REMARKS

FIGURE 1

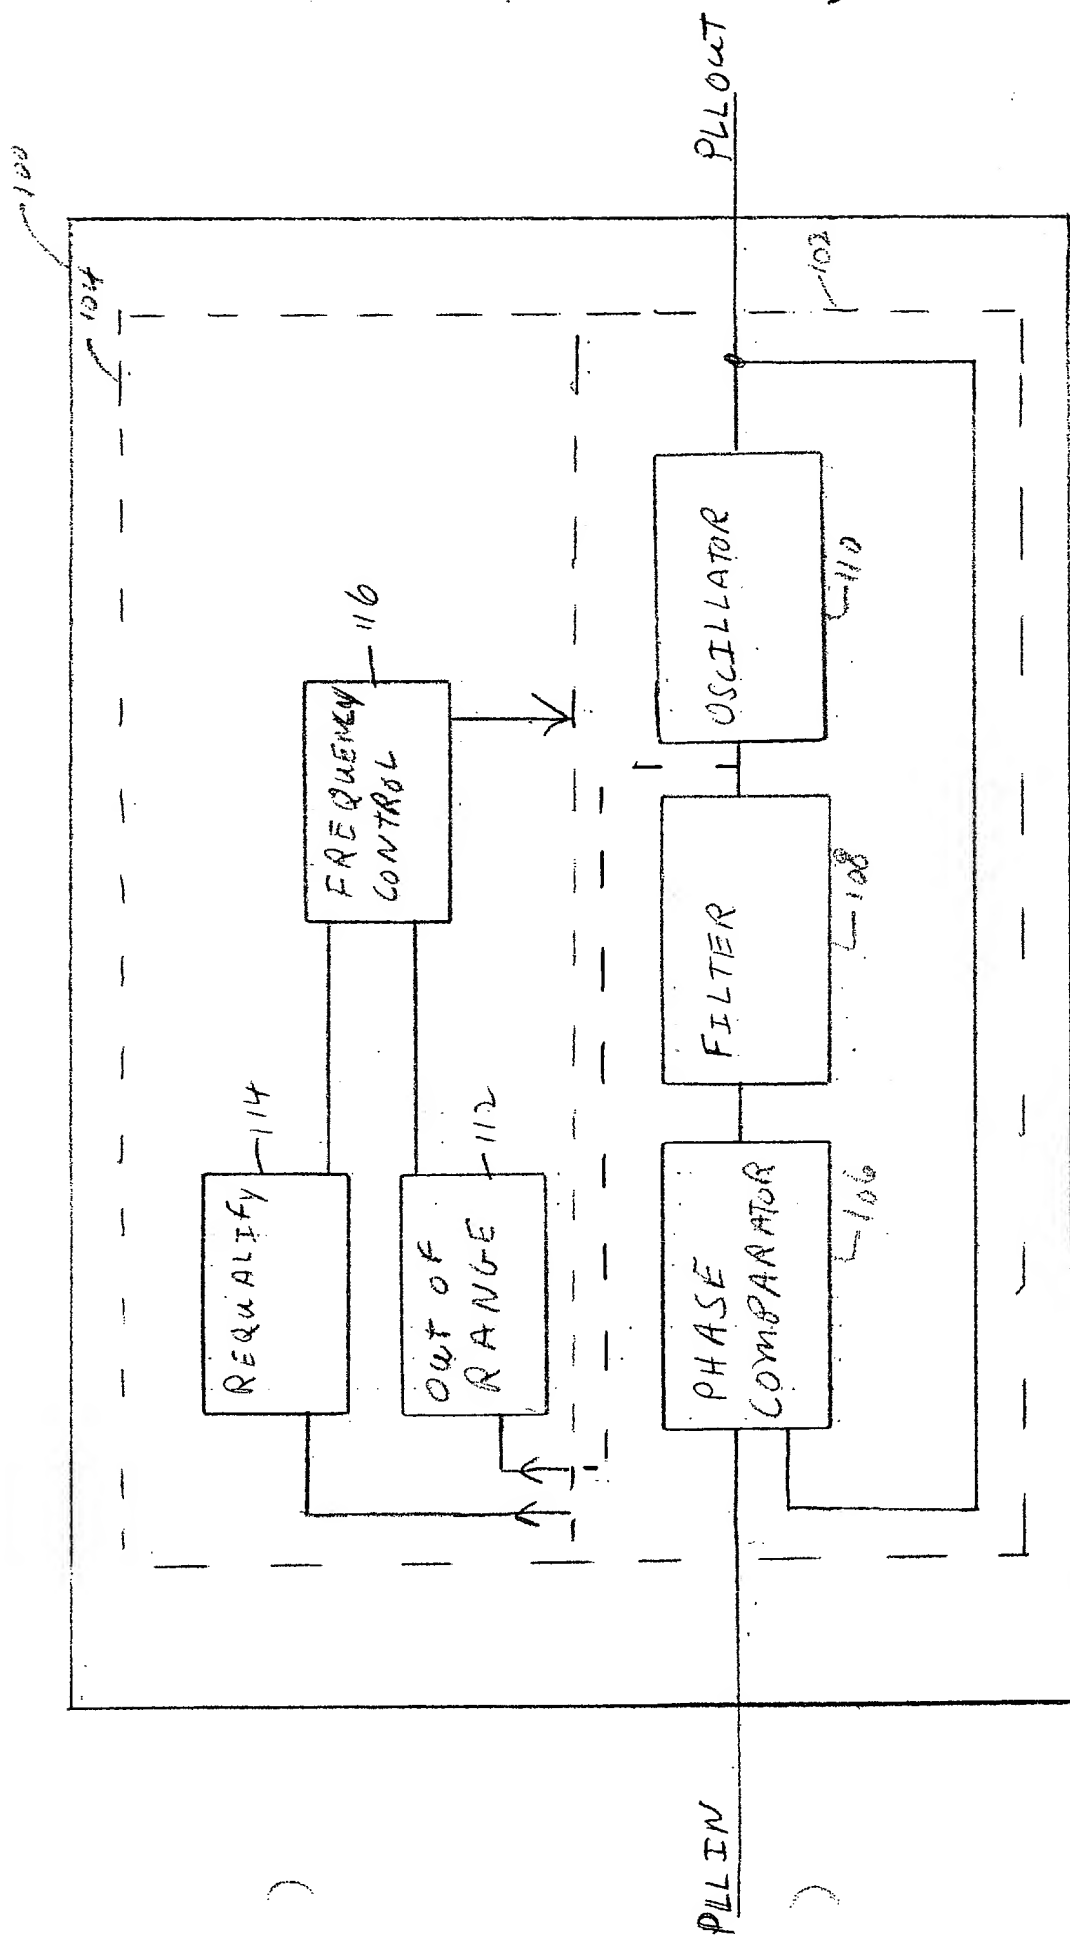
~~The drawings were objected to under 37 CFR 1.83(a). The examiner indicated that~~
"the control circuitry connection to the input signal as recited in claim 1 must be shown .
." ~~The feature recited in old claim 1, and in new claims 26-55 is "control circuitry~~
responsive to deviations of the PLL input signal's frequency. . ." ~~The control circuitry~~
~~detects such deviations in a variety of ways. For example, as illustrated in Figure 2 and~~
~~described in the discussion related thereto, the control circuitry monitors such frequency~~
~~deviations via a connection between the output of the A/D converter 120 and the control~~
~~circuitry 105. Or, as illustrated in Figure 3 and described in the discussion related thereto,~~
~~the frequency monitoring is achieved via a connection between the output of the phase~~
~~comparator 106 and the beat detector 126. No connection between the input signal and~~

However, the limitation of "measuring the voltage of said control signal coupled to
the oscillator" is included in the claims and it is assumed that this is the limitation to which
the Examiner objected. Because the connection between the control circuitry 104 and the
PLL circuitry 102 may be made in a variety of ways, the connection between the control
signal coupled to the oscillator 110 and the out of range detector 112 in the higher-level
conceptual block diagram of Figure 1 is indicated as a dotted red connection line in the
proposed amendment to Figure 1. That is, the connection between the control circuitry 104
and the PLL circuitry 102 may be made, for example, between a beat detector 126 and the
phase comparator 106 of Figure 3, between the digital output of the A/D converter 120 and
the controller 105 of Figure 2, or between an out of range detector 112 and the control
signal coupled to the oscillator 110. Consequently, the connection between line between

the output of the filter 108 and the out-of-range detector 112 of Figure 1 is indicated as a
dotted, rather than solid, line.
